Re: Florida Power & Light Company
Proposed Turkey Point Units 6 and 7
Docket Nos. 52-040 and 52-041
Voluntary Revised Response to NRC Request for Additional Information Letter No. 61 (eRAI 6432) Related to SRP Section 03.07.01 - Seismic Design Parameters

Attachment: FPL Revised Response to NRC RAI No. 03.07.01-19 (eRAI 6432)

NRC RAI Number: 03.07.01-19 (eRAI 6432)

Figure 2.5.2-249 Median Profiles of Strain-Compatible Soil Damping
(Upper 800 feet) (Sheet 2 of 2)

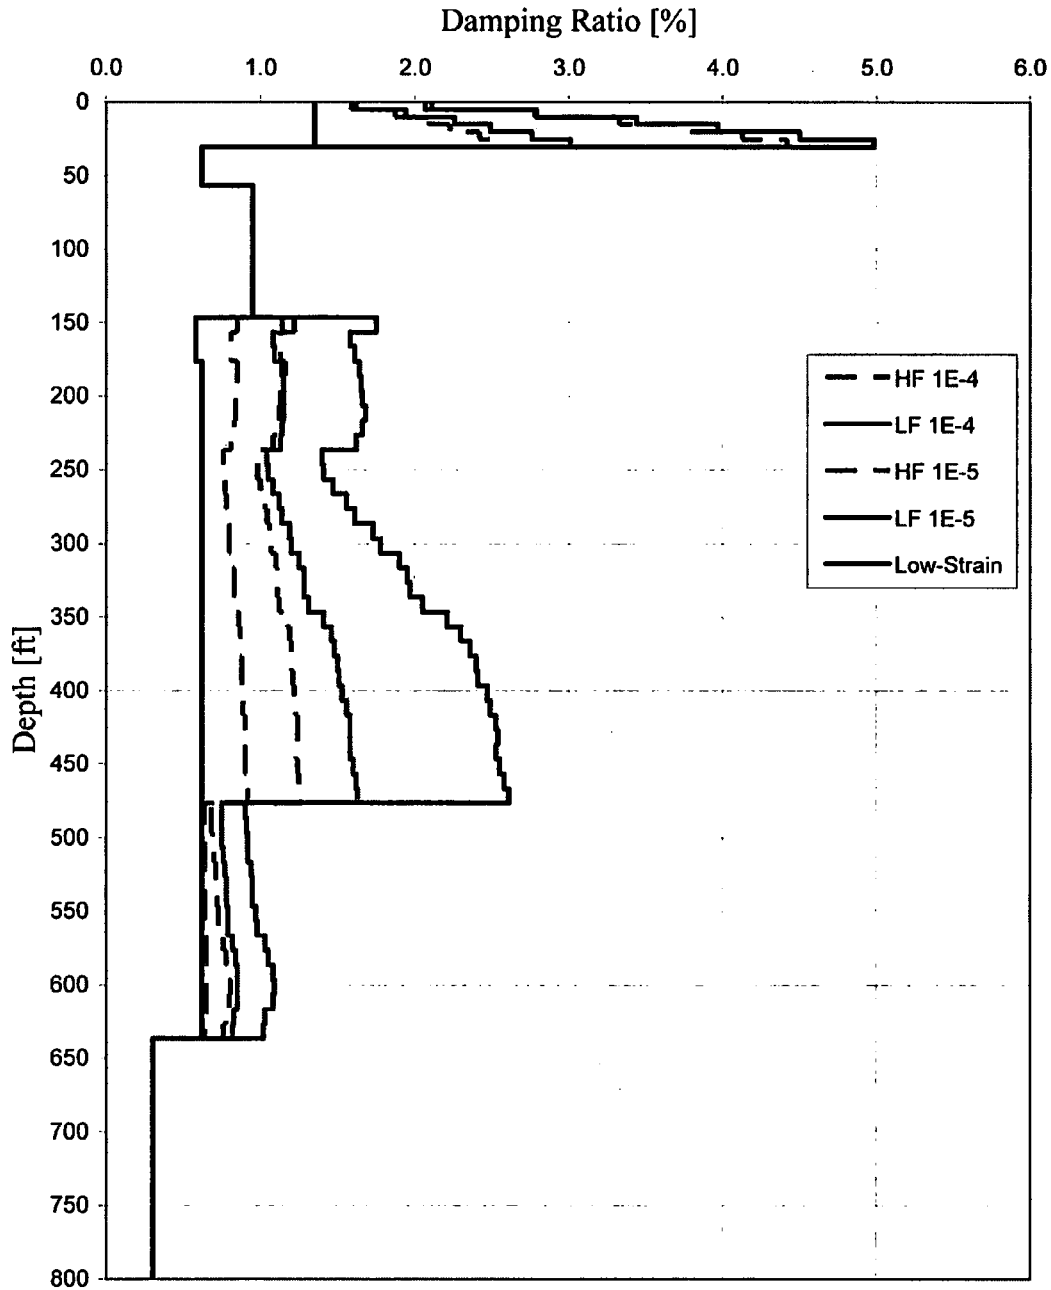
In Revision 3 of the applicant's FSAR, (aka. TPG-1000-S2R-802, "Turkey Point Site-Specific Seismic Evaluation Report") the third paragraph in Section 2.5.4.7.3.3, "Shear modulus and Damping for Rock," states that the damping for rock is taken as 1%. The damping shown in Figure 2.5.2-249 which describes the soil properties used to develop the GMRS indicates that a damping value of ½% was used in the analyses. The applicant is requested to provide clarification as to the actual level of damping used in the analyses, including the SSI analyses, and provide basis for selection considering the large variability in RQD shown in Figure 2.5.4-215.

FSAR Figure 2.5.2-249 (Sheet 2 of 2) is reproduced in this response for illustrative purposes. This figure represents the full soil and rock column that includes approximately 30 ft of structural fill (with surface at El. +25.5 ft NAVD 88) above approximately 25 ft of Miami Limestone, overlying about 90 ft of rock consisting of the Key Largo and Fort Thompson Formations. The rock is underlain by soil of the Tamiami and Peace River Formations to about 475 ft depth. The Arcadia Formation, consisting of very weak rock mixed with some soil extends to about 640 ft depth, the limiting depth of the site subsurface investigation. The actual levels of damping used in the analyses are the values shown in FSAR Figure 2.5.2-249 (Sheet 2 of 2). The basis for selecting the value for each formation is described in the following paragraphs.

FSAR Subsection 2.5.4.7.3.3 indicates that the Miami Limestone is considered sufficiently weak to have strain-dependent modulus and damping values. FSAR Table 2.5.4-216 shows the damping ratio (D, percent) versus shear strain values. D remains constant at 0.6 percent from 0.0001 to 0.03 percent strain. In the SHAKE analysis, shear strain did not exceed 0.03 percent, and so D is constant at 0.6 percent in FSAR Figure 2.5.2-249 (Sheet 2 of 2).

D = 1 percent at all strain levels for the Key Largo and Fort Thompson Formations (Strata 3 and 4). As Part of the supplemental field investigation as discussed in the revised response to RAI 02.05.04-3 (Reference 1), four resonant column torsional shear tests (RCTS) were conducted on the Key Largo and Fort Thompson formations. The RCTS results, as obtained from the supplemental field investigation testing, are used to create the best fit damping curve labeled "Key Largo and Fort Thompson" in FSAR Figure 2.5.4-235. The maximum shear strain that these strata experience is much smaller than 0.005 percent (FSAR Figure 2.5.2-248). For this strain interval, the

damping ratio is first constant around 0.8 percent, and then increases towards 1 percent as the shear strain approaches 0.005 percent. Even though the assumed damping ratio of 1 percent is slightly higher than the measured value, the test results can be considered in good agreement with the assumptions made for this layer and the difference is within the uncertainty involved in determining the damping ratio from the test results.

The only other rock formation noted in FSAR Subsection 2.5.4.7.3 is Stratum 8, the Arcadia Formation. The Arcadia Formation is much weaker than the Key Largo and Fort Thompson Formations. FSAR Table 2.5.4-209 indicates an unconfined compressive strength of about 140 psi compared with about 2700 and about 2300 psi for the Key Largo and Fort Thompson Formations, respectively. Even the strain-dependent Miami Limestone has higher strength than that of the Arcadia Formation. Thus, for the Arcadia Formation, consideration was given to using the D versus shear strain values of the Miami Limestone (Oolite) given in FSAR Table 2.5.4-216. However, since the Arcadia Formation is the lower portion of the Hawthorn Group, with the overlying Peace River Formation (FSAR Subsection 2.5.1.1.1.2.1.1) forming the upper portion, it was considered more appropriate to use the D versus shear strain values of the Peace River Formation for the Arcadia Formation.

The constant damping ratio of the material below the Arcadia Formation, (i.e., below about 640-ft depth in FSAR Figure 2.5.2-249, Sheet 2 of 2), is 0.32 percent based on the median value of kappa and associated uncertainty.
